Modification Report

Section 4.55 Modification Application

Mixed-use Development including Affordable Housing

SSD-71454709 MOD 1

Figure 5: Proposed Basement Level 1
(source: Bonus + Associates)

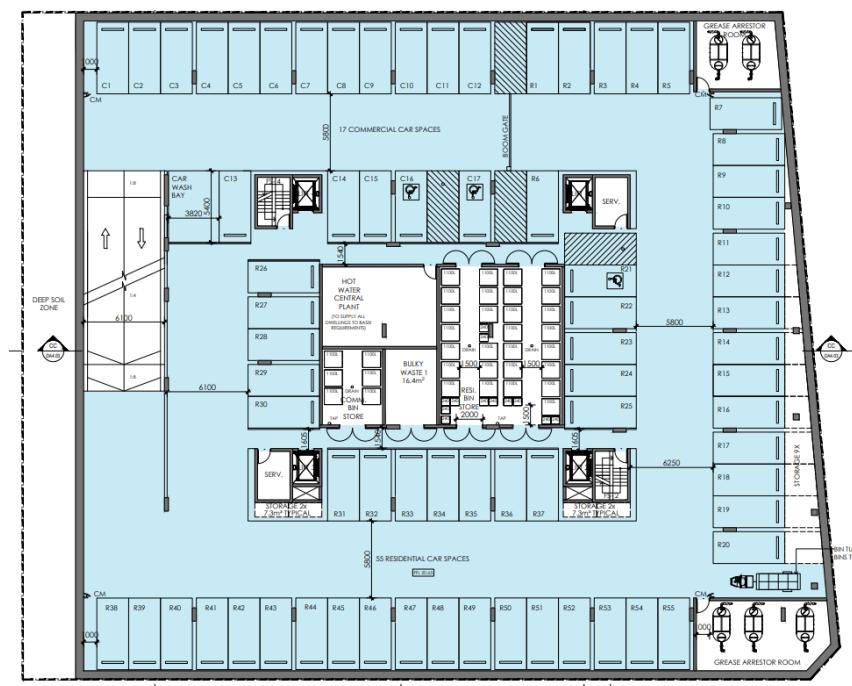
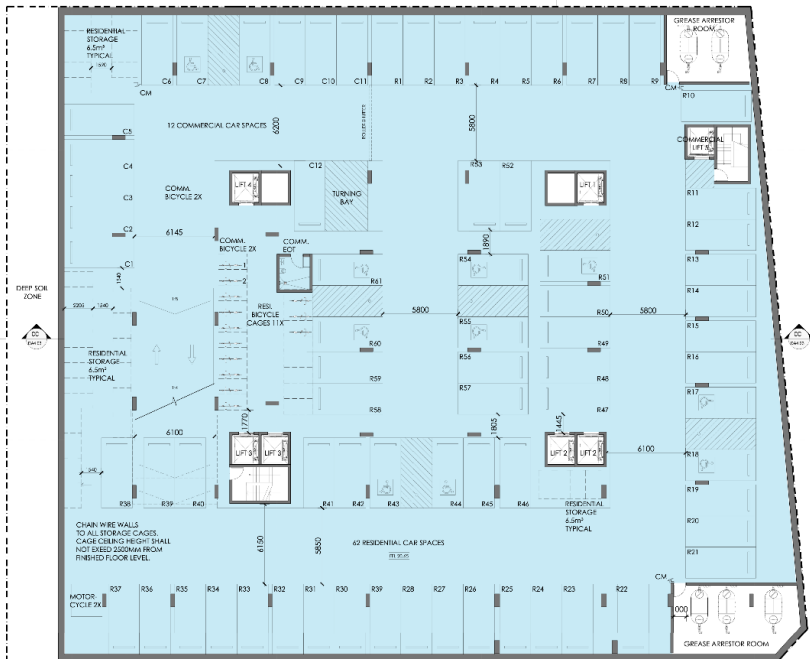
The modified development results in reduced parking demand such that 1 basement level is no longer required. Changes to parking and basement design can be seen in Figures 4 and 5 and include:

Other changes to the layout of Basement Level 1 include

- Vehicle access ramp relocated
- Waste storage removed and relocated to Ground Floor level
- Waste bin tug and trailer parking space deleted
- Hot water central plant room deleted
- Residential storage reduced / relocated to Ground Floor level.
- Additional residential lifts provided.
- Dedicated Commercial lift provided to connect car parking at Basement with Padstow Parade

Figure 6: Approved and Proposed Servicing Arrangements
(source: Bonus + Associates)

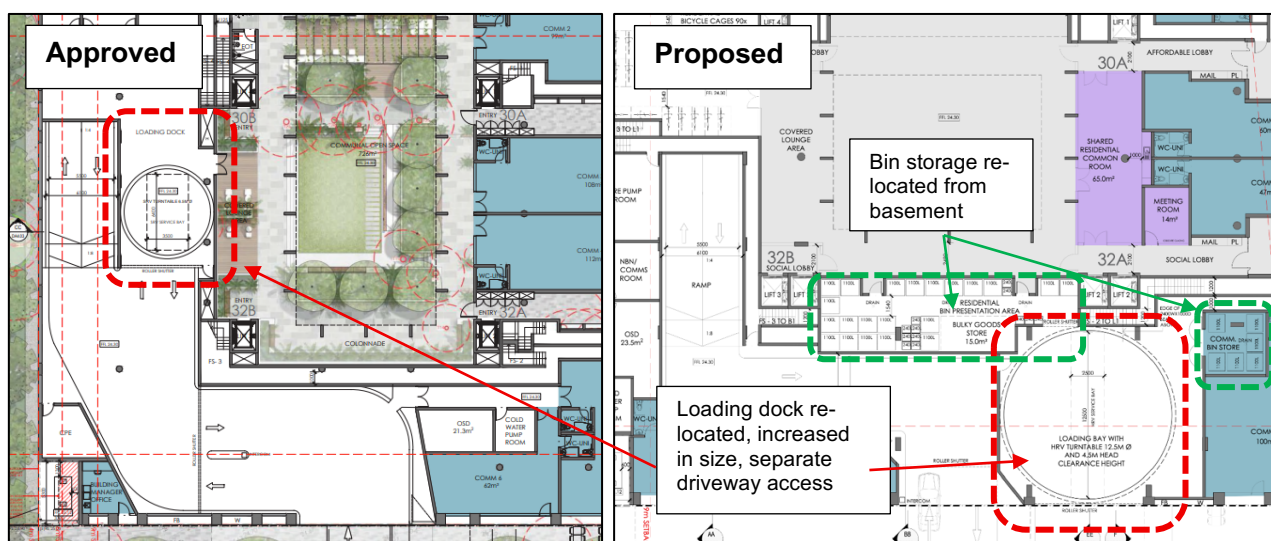
To reduce operational costs for Homes NSW to enable affordable housing provision, and noting that a laneway adjacent to the site may never be delivered, modifications to servicing are proposed in order to accommodate a HRV / council waste vehicle. It is also proposed to relocate bin storage from the basement to the ground floor. Key changes can be seen in Figure 6.

The revised location of the loading dock also means that servicing can be separated from general vehicle access, reducing the potential for vehicle conflicts. Revised swept path diagrams are included in the Traffic Impact Assessment at Appendix I.

Figure 7: Approved and Proposed Communal Open Space Arrangements
(source: Land FX)

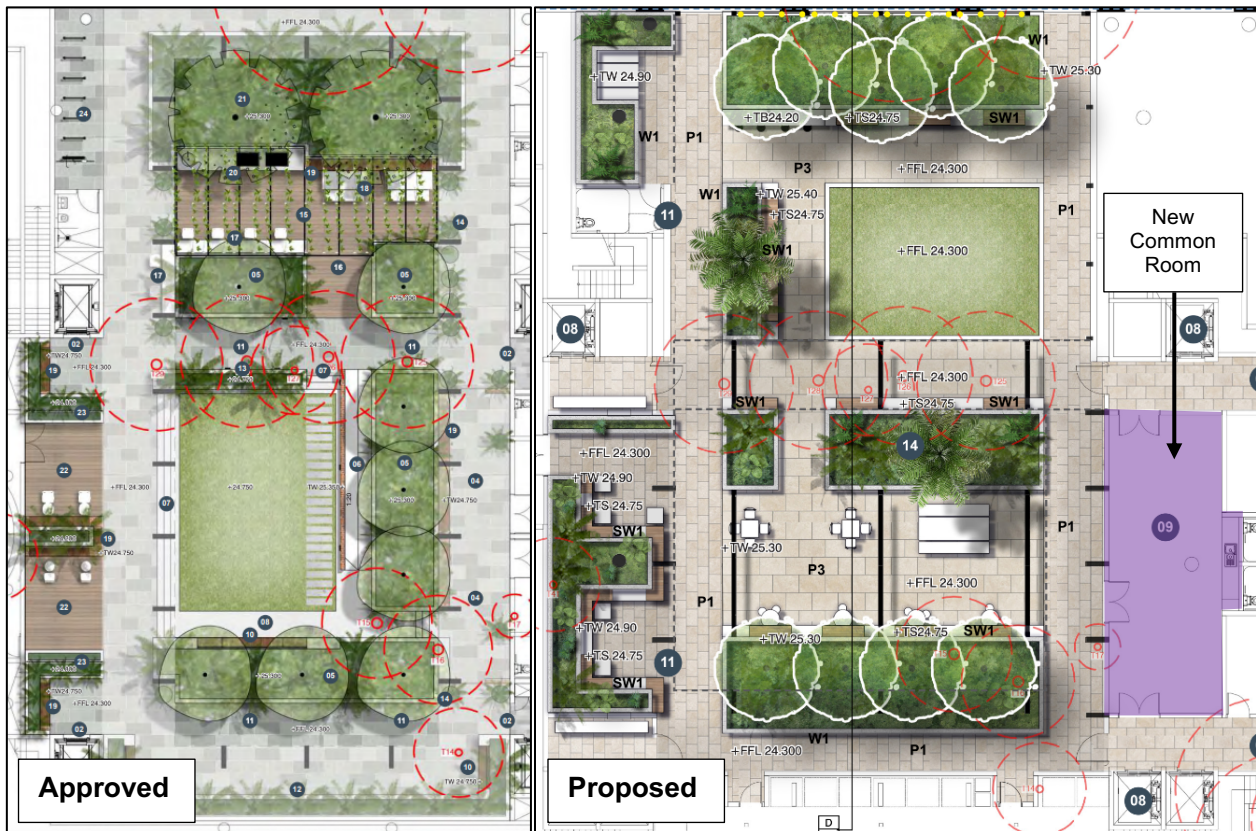
However, this reduction is offset by a proposed new shared residential common room of 65m² directly adjacent to and accessible from the communal open space. The modification therefore results in total communal space of 762m², a net improvement on the total communal space available.

The design of the communal open space has also been updated to reflect the revised layout arrangements. Overall tree planting and canopy cover within the space is slightly improved with 11 trees proposed (6 small and 5 medium trees) in place of 10 approved trees (8 small and 2 medium).

Areas for passive recreation including a lawn area and a range of seating areas are all retained. Importantly, as described above, the space is now proposed to be for the exclusive use of residents, with all commercial access to eh space removed.

Figure 8: Extract from Level 4 Plan indicating key changes to a typical floor level
(source: Bonus + Associates)

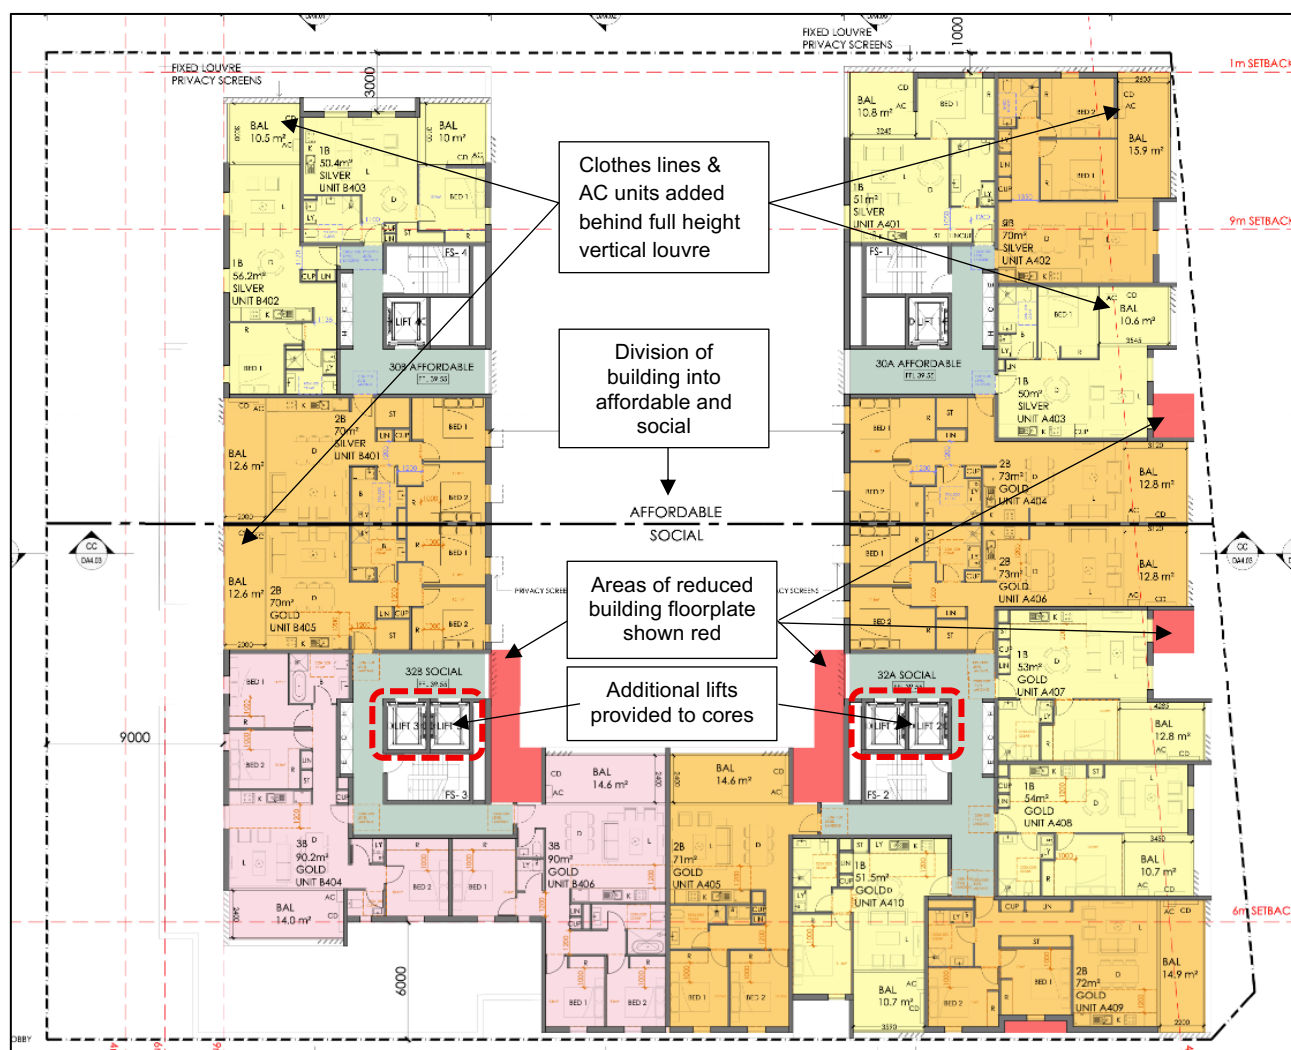
- Updated internal unit and balcony designs (all revised dwellings remain compliant with ADG floorspace and design recommendations)
- Small changes to the floorplate at each level – all changes within the existing approved building envelope with some small reductions in floorplate

- 113 dwellings retained, but modifications to unit mix as follows:
 - 44 proposed x 1 bedroom (+7 units)
 - 60 proposed x 2 bedroom (-8 units)
 - 9 proposed x 3 bedroom (+1 unit)

- Provision of additional lifts to two lift cores
- Arrangement of dwellings around two social housing lift cores and two affordable housing lift cores
- Clothes lines and AC condensers added to each balcony behind full height vertical louvre screens

Figure 9: Approved and Proposed Padstow Parade Elevations
(source: Bonus + Associates)

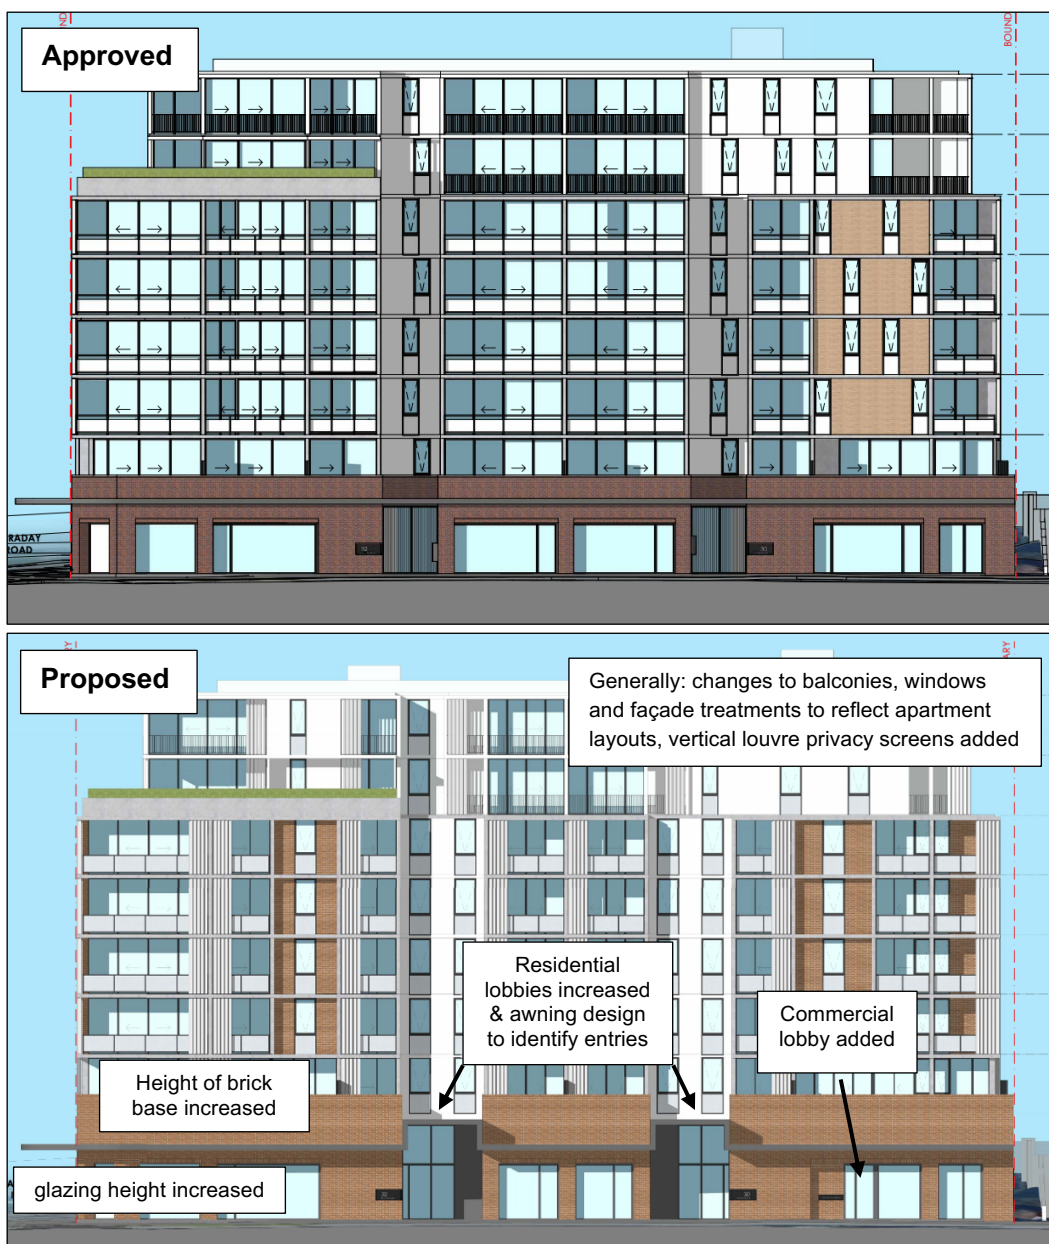
Changes to the facades, arising predominantly from the above modifications, include:

- Height of brick base to the building increased in height by 1.45m
- Additional loading dock access door to accommodate HRV
- Height of shopfront glazing increased from 2.7m to 3.0m
- Width of residential entry lobbies increased, width of commercial tenancy reduced accordingly
- Padstow Parade awning revised to improve the visibility of the residential entry lobbies
- Commercial shop fronts to Faraday Road revised (overall length of active façade increased)
- Screening provided to sub-station
- Location and arrangement of residential windows and balconies revised to reflect the revised apartment layouts, including reduction in extent of balconies to Faraday Road
- Vertical louvre privacy screens added to screen clothes drying facilities
- Balustrade design revised to suit Homes NSW requirements for privacy and durability.

Figure 10: Approved and Proposed Faraday Road Elevations
(source: Bonus + Associates)

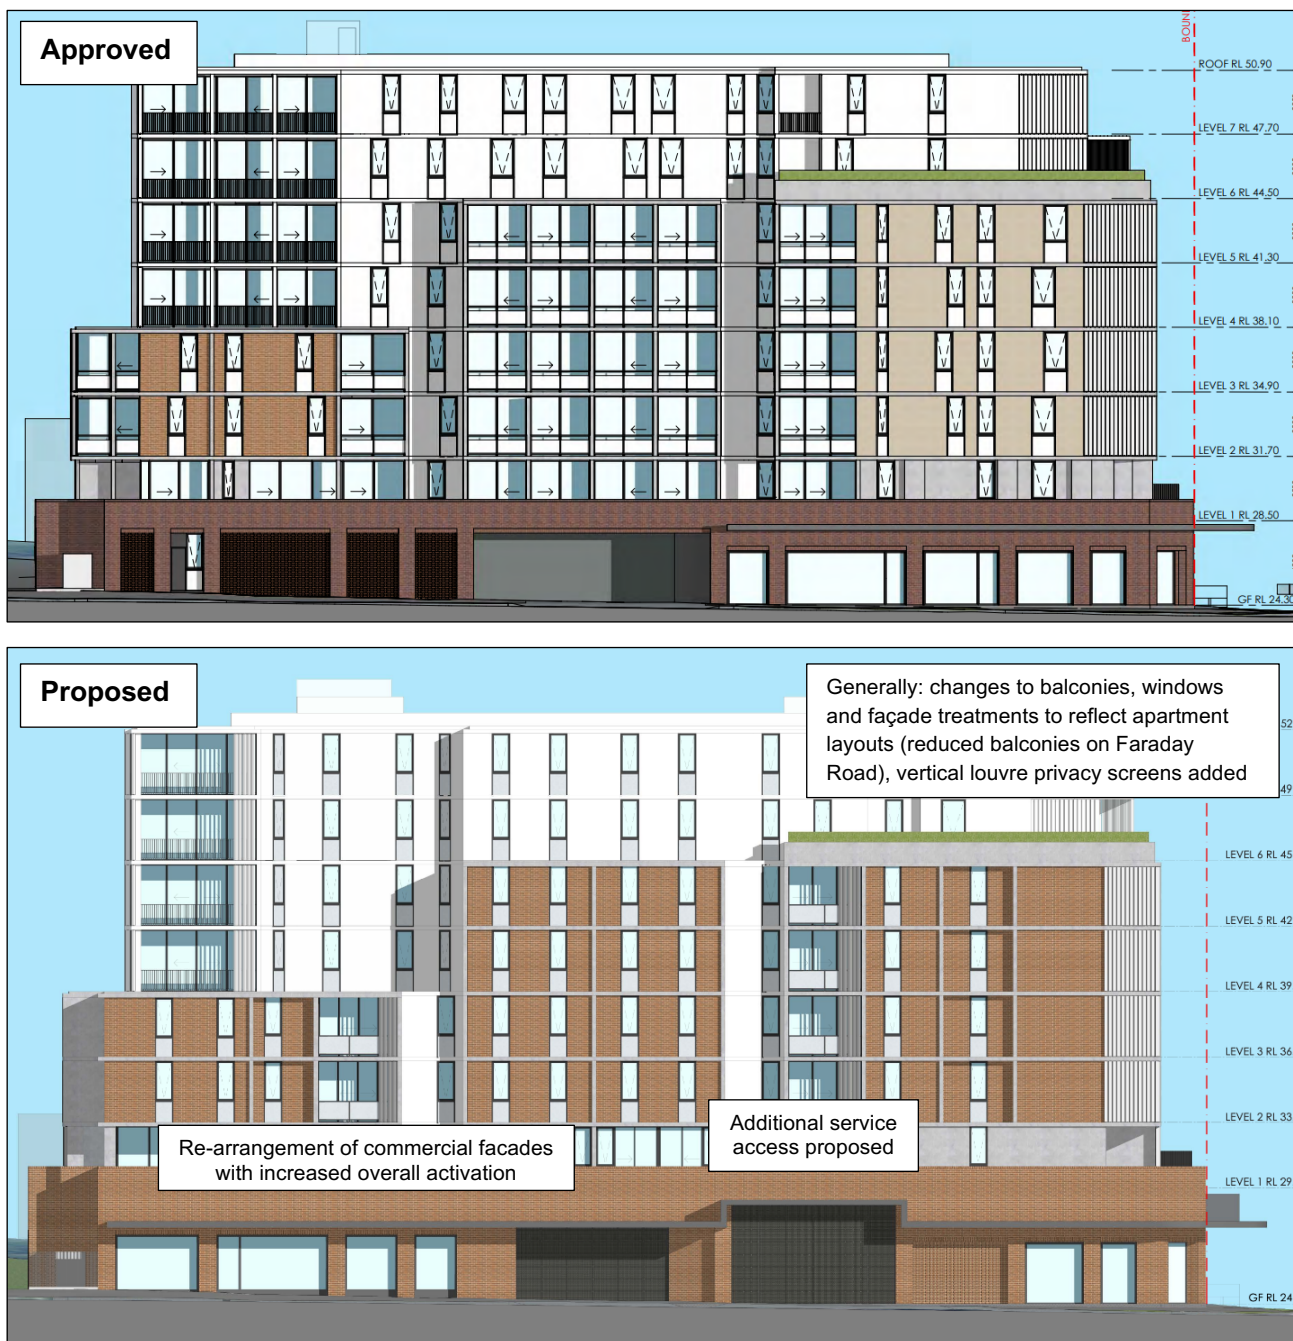
Commercial floorspace fronting Faraday Road is re-arranged, but the overall level of activation is improved on this frontage as seen in Figure 10.

Figure 11: Approved and Proposed Faraday Road Street Trees
(source: Bonus + Associates)

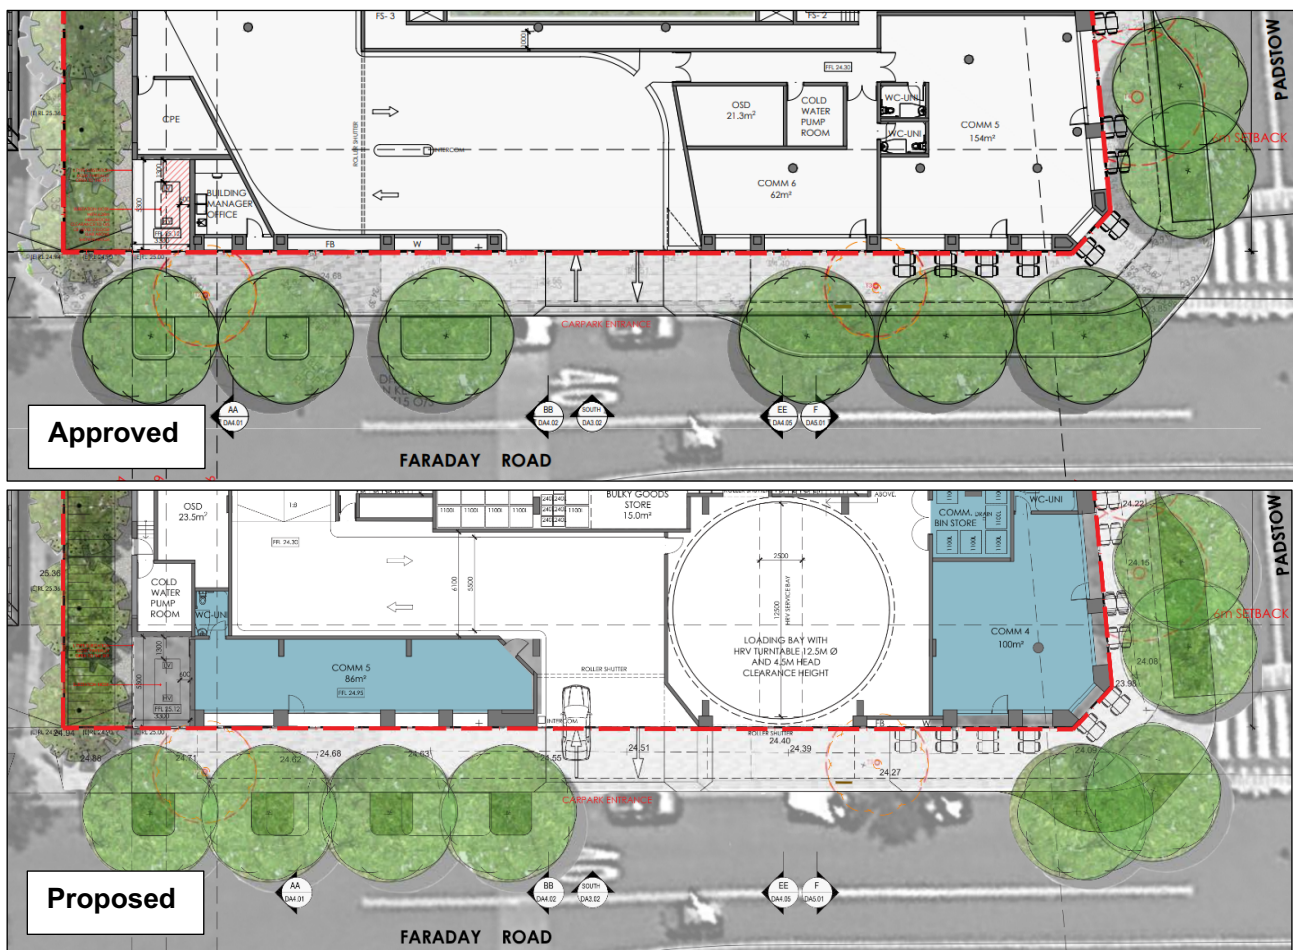
The proposed new loading dock driveway affects the approved street tree and on-street parking arrangements on Faraday Road. As a result, street trees and parking are proposed to be re-arranged as shown in Figure 11.

Figure 12: Perspective images of approved and proposed modified development with 26m building height plane
(source: Bonus + Associates)

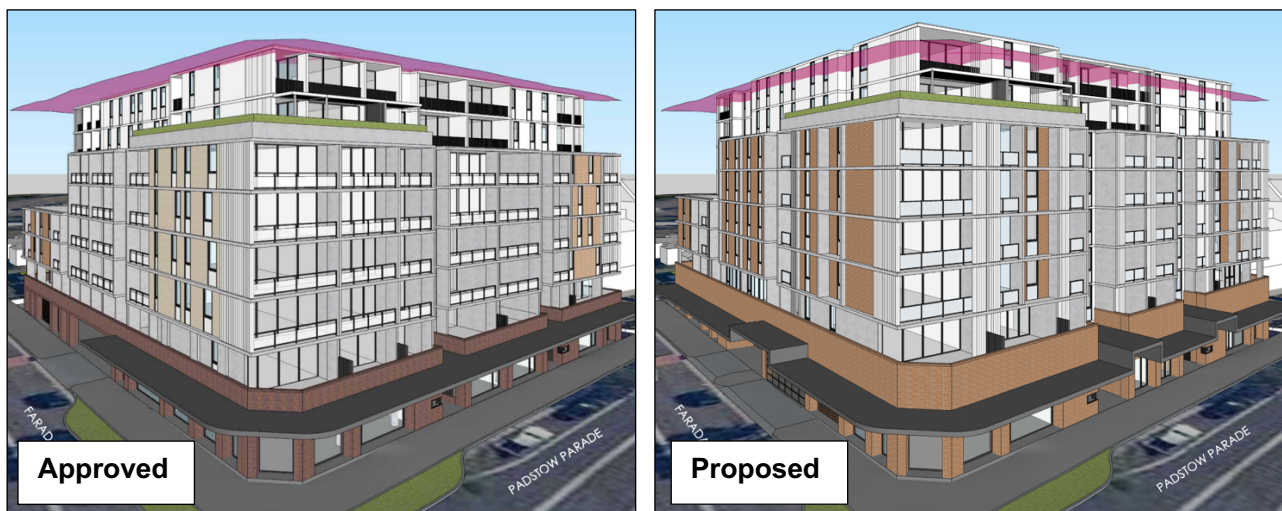
The proposed modification includes an additional increase in building height of 1.45m, resulting in maximum building height of 28.7m and a total height variation of 2.7 metres, or 10%.

The change to building height, and the extent of the non-compliance can be seen in Figure 12. Essentially, the modification will result in a building that presents as half a storey higher than expected by the planning controls, although the non-compliant elements will not be readily discernible from the immediate public domain, noting the upper floors of the building are already setback from the main building line and therefore are not visually prominent within the streetscape.
